Process Change Notification

Date: Friday, July 10, 2015
PCR Reference: 220
PCN Reference: 220-PCN90-Public

Additional assembly site for TO-220 and D2Pak IGBT products Super Power Semiconductors (Korea) will be the alternate assembly site for the part numbers identified in the following page. As a result of this change, the package will change as follows

TO220-AB POD COMPARISON

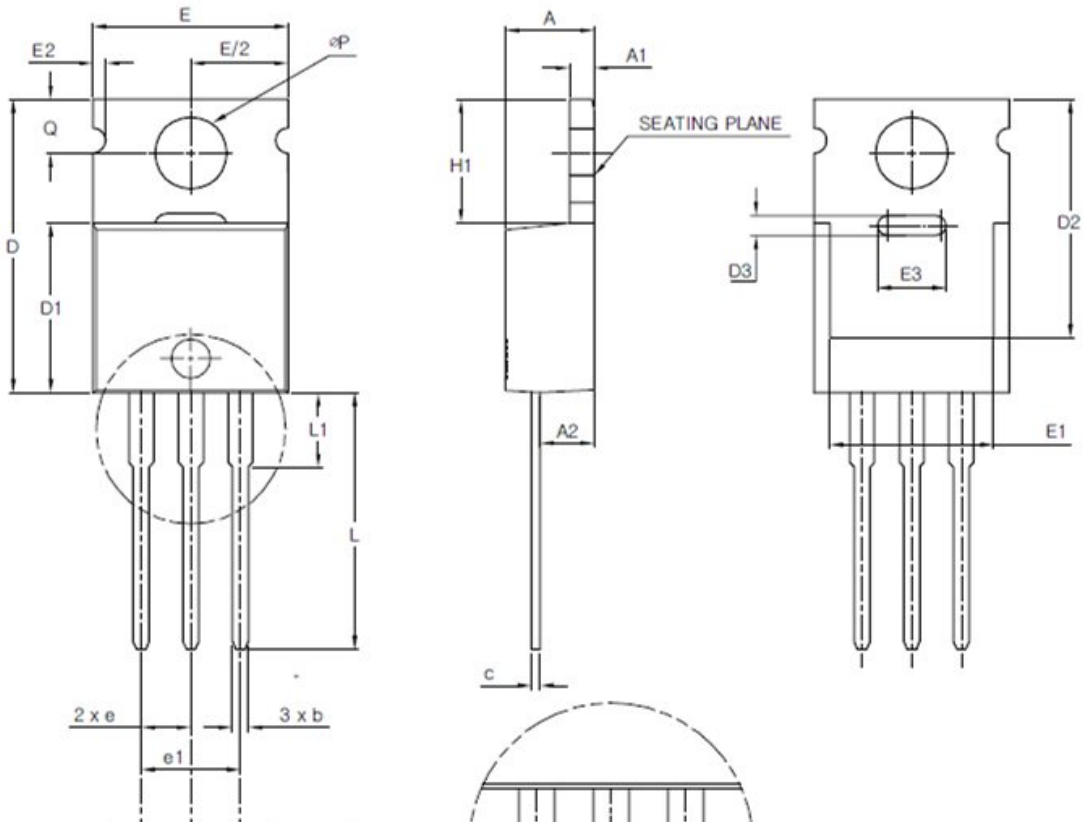
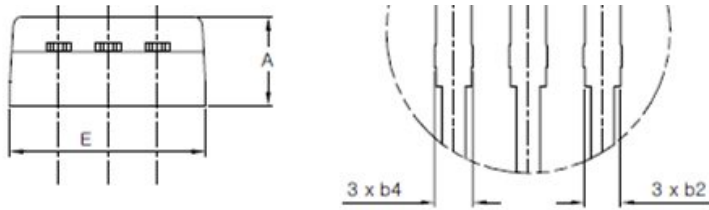
Package Outline Comparison TO-220

Reference	IR POD		SP POD		JEDEC POD	
	Min	Max	Min	Max	Min	Max
A	3.56	4.83	3.56	4.83	3.56	4.83
A1	0.51	1.40	0.51	1.40	0.51	1.40
A2	2.03	2.92	2.03	2.92	2.03	2.92
b	0.38	1.01	0.38	1.01	0.38	1.01
b2	1.14	1.78	1.14	1.78	1.14	1.78
c	0.36	0.61	0.36	0.61	0.36	0.61
D	14.22	16.51	14.22	16.51	14.22	16.51
D1	8.38	9.02	8.38	9.02	8.38	9.02
D2	11.68	12.88	11.68	12.88	12.19	12.88
E	9.65	10.67	9.65	10.67	9.65	10.67
E1	6.86	8.89	6.86	8.89	6.86	8.89
e	100 BSC		100 BSC		100 BSC	
H1	5.84	6.86	5.84	6.86	5.84	6.86
L	12.70	14.73	12.70	14.73	12.70	14.73
L1	3.56	4.06	3.56	4.06	3.56	4.06
ØP	3.54	4.08	3.54	4.08	3.54	4.08
Q	2.54	3.42	2.54	3.42	2.54 </td <td>3.42</td>	3.42

D2pak POD Comparison

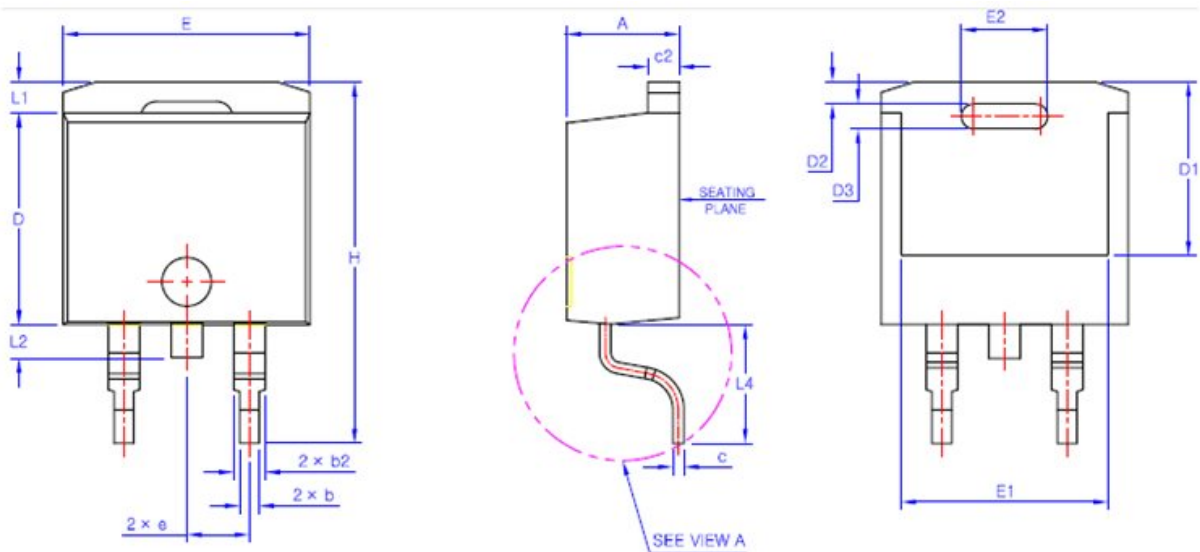
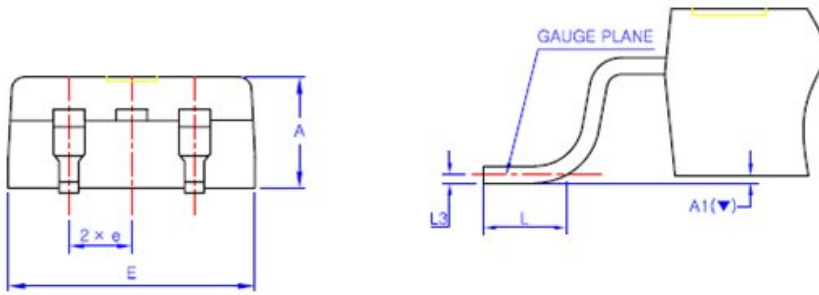
Package Outline Comparison D2Pak

Reference	IR POD		SP POD		JEDEC POD	
	Min	Max	Min	Max	Min	Max
A	160	190	160	190	160	190
A1	-	10	-	10	-	10
b	10	39	10	39	20	39
c	20	29	20	29	15	29
c2	45	65	45	65	15	65
D	330	380	330	380	330	380
D1	270	-	270	-	270	-
E	380	420	380	420	380	420
E1	245	-	245	-	245	-
e	100 BSC		100 BSC		100 BSC	
H	575	625	575	625	575	625
L	70	110	70	110	70	110
L1	-	66	-	66	-	66
L2	-	70	-	70	-	70
